ALTITUDE HOTEL & RESIDENCES

Downtown DRB
Design Recommendation Meeting No. 1

DPD# 3018037
August 16, 2016

FORM ANALYSIS - MASSING CONCEPT

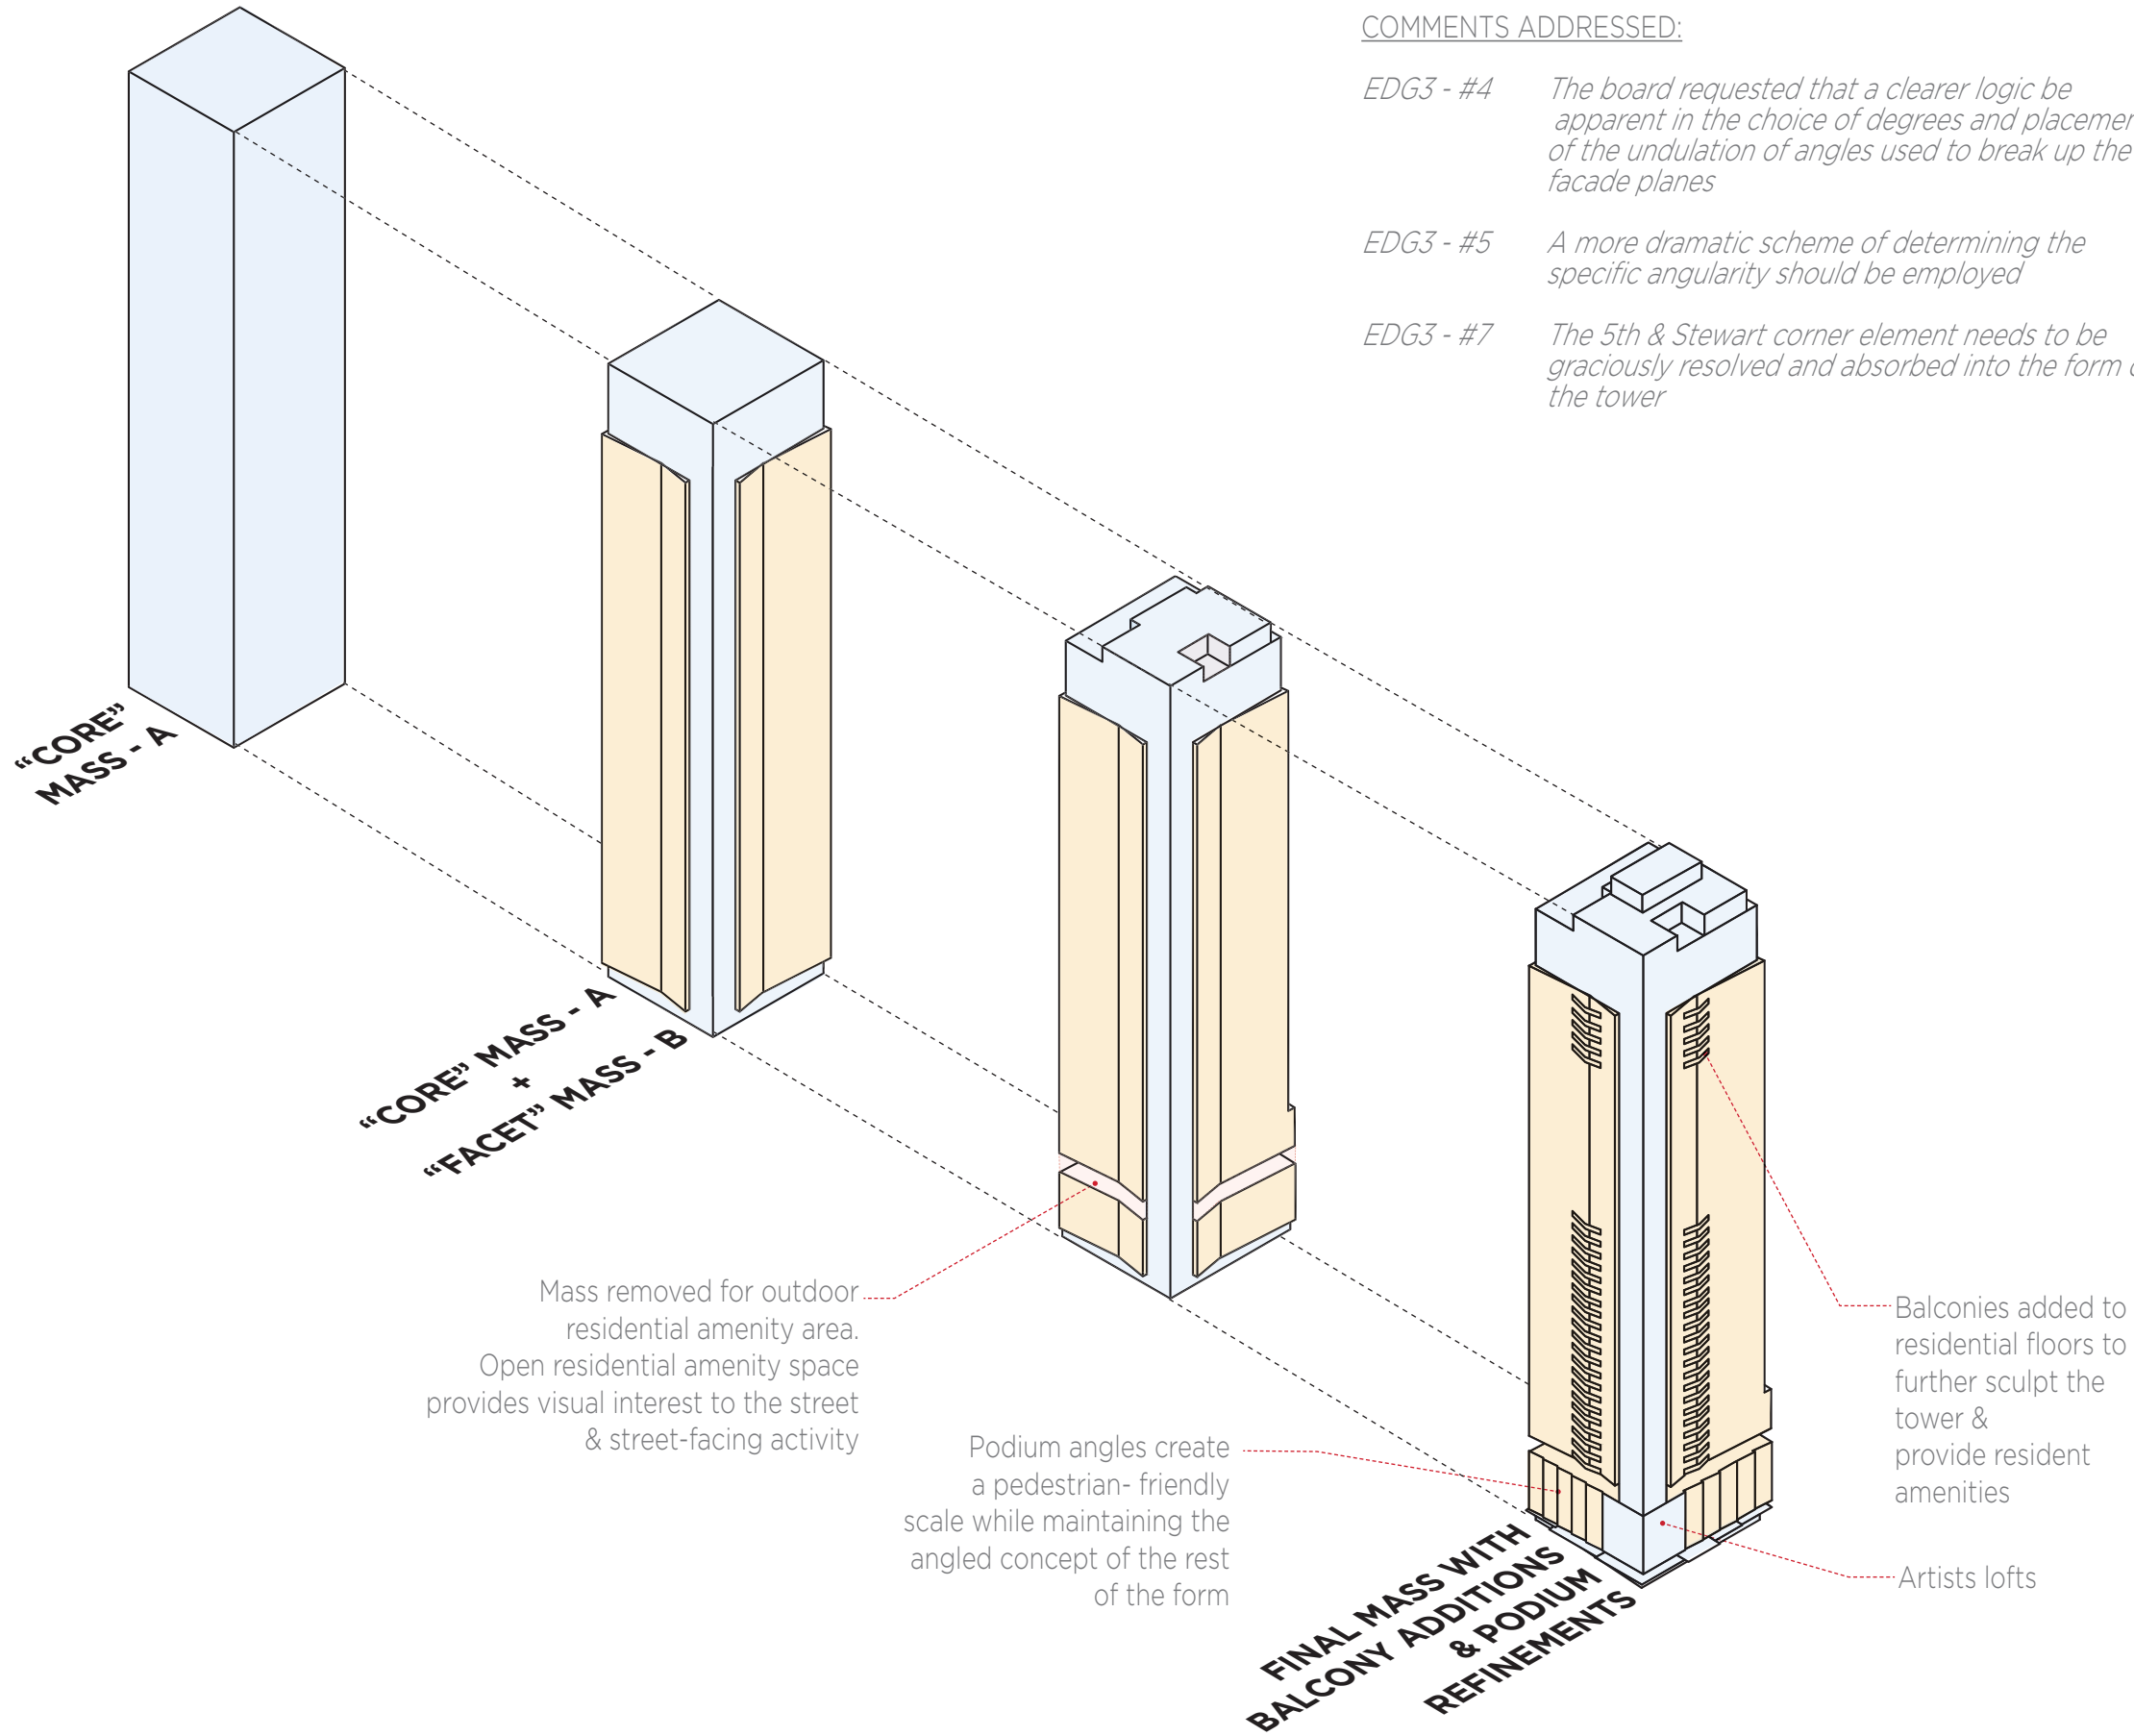
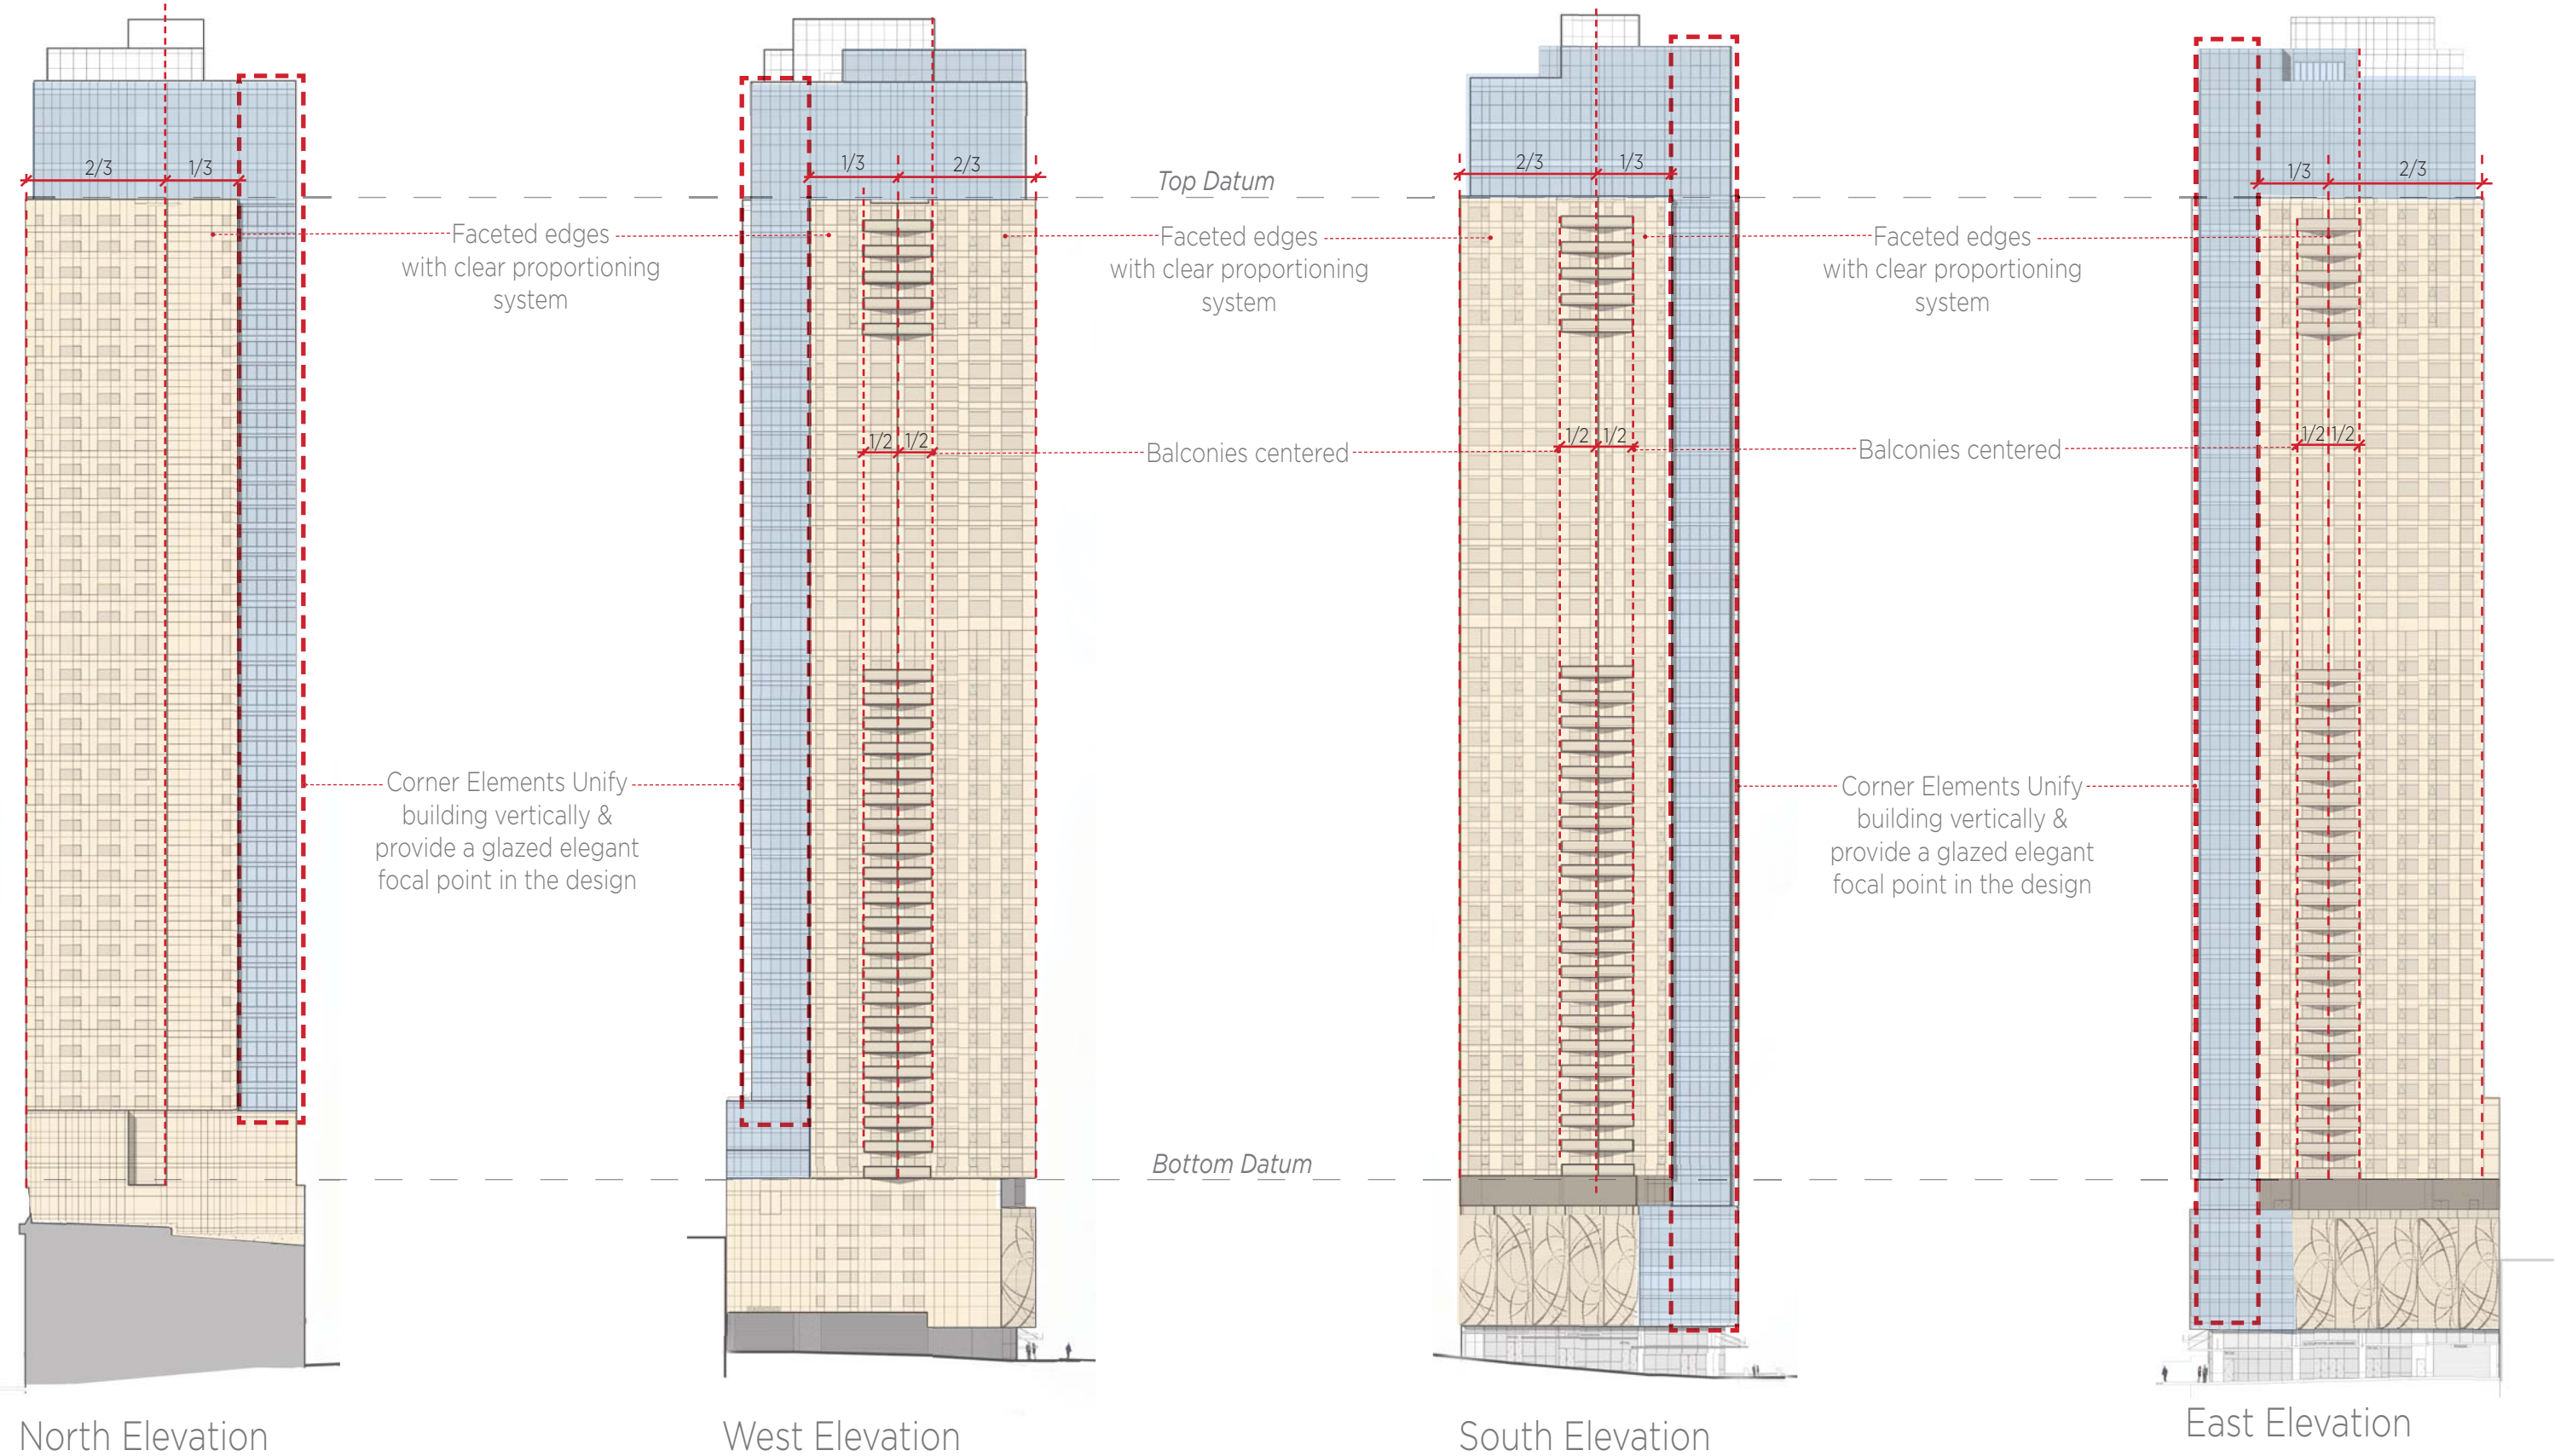
- EDG3 - #4 *The board requested that a clearer logic be apparent in the choice of degrees and placement of the undulation of angles used to break up the facade planes*
- EDG3 - #5 *A more dramatic scheme of determining the specific angularity should be employed*
- EDG3 - #7 *The 5th & Stewart corner element needs to be gracefully resolved and absorbed into the form of the tower*

"Core" Mass - A
This mass acts as a unifying element of the building & as a "Gateway" element representing the transition from the Downtown neighborhood into the Belltown neighborhood.

"Facet" Mass - B
The angles of the facade are a direct response to the views to the nearby towers. Each facade is slightly angled with an emphasis towards an improved view outwards.

ELEVATION STUDY - NORTH FACADE

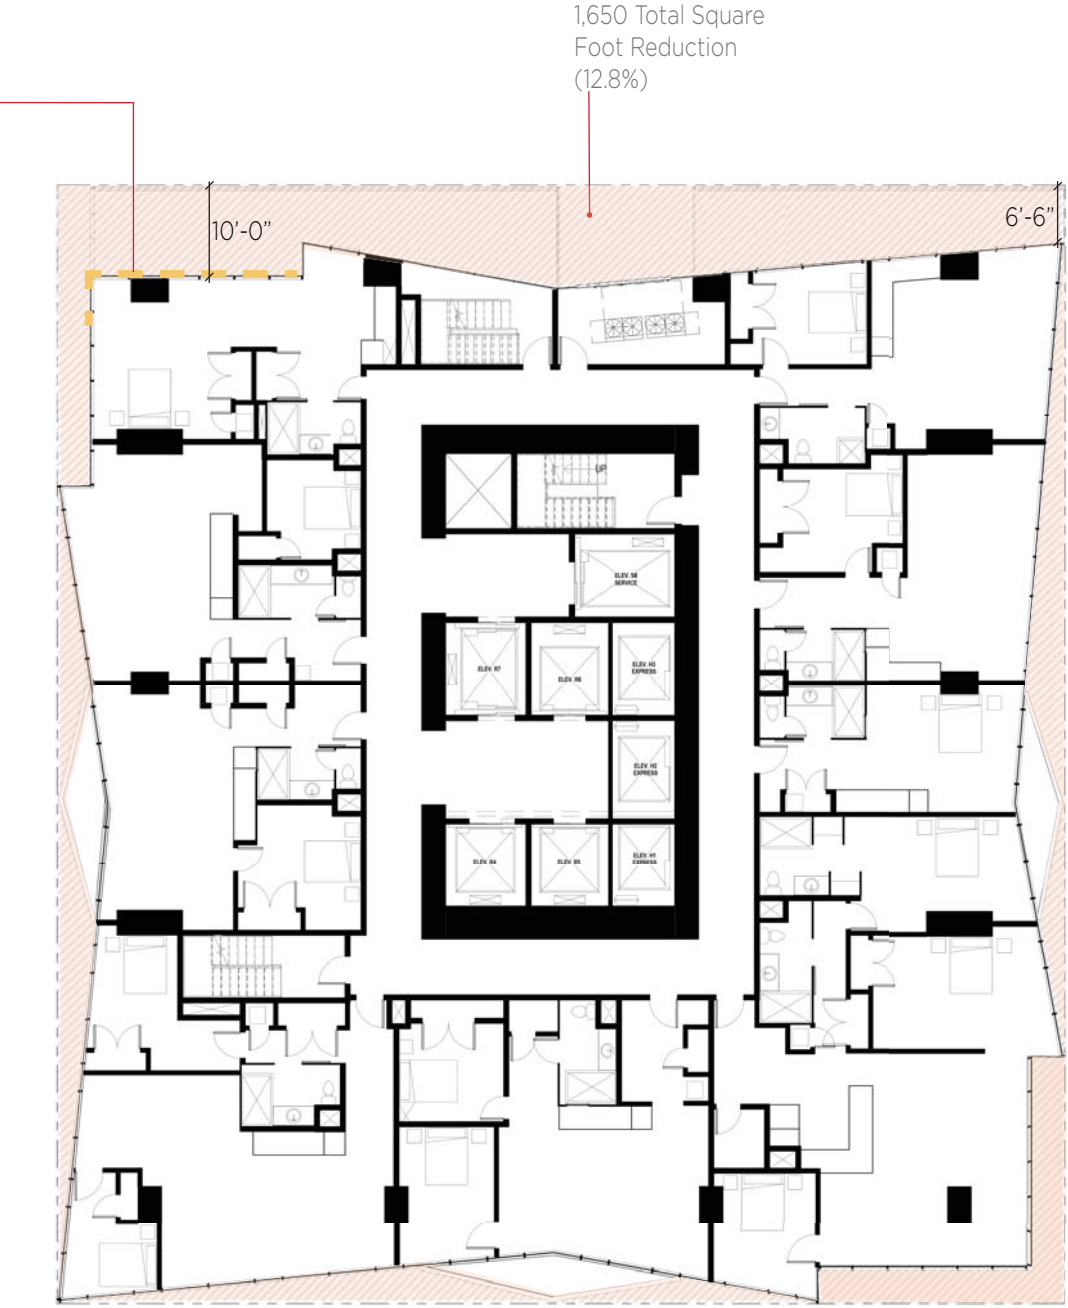
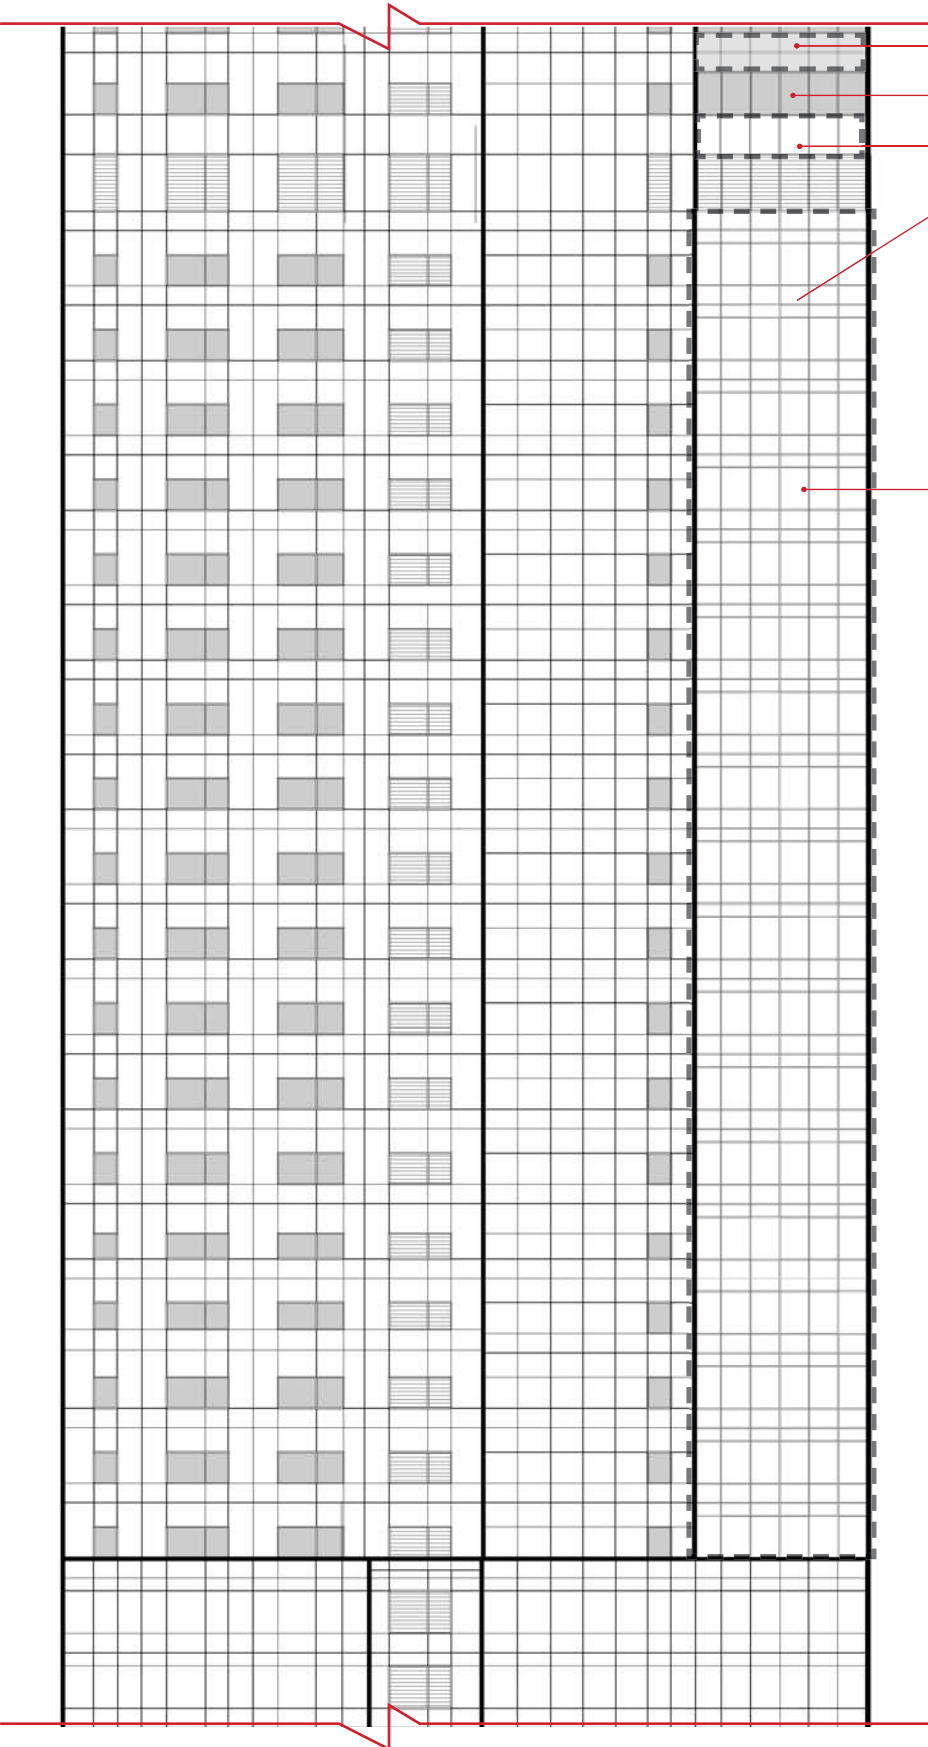
COMMENTS ADDRESSED:
EDG3 - #8 The north facade prevents the 360 degree unity of the tower

North Facade
Transparent Glazing Analysis:

81.3% Solid Facade
18.7% Transparent Glazing

versus +/- 42% transparent glazing for the West, South, & East facades

Due to the proximity of the north facade to nearby neighbors, special attention was given to the north facade that significantly minimized transparent glazing without compromising the overall design intent & creating a 360 degree elevation
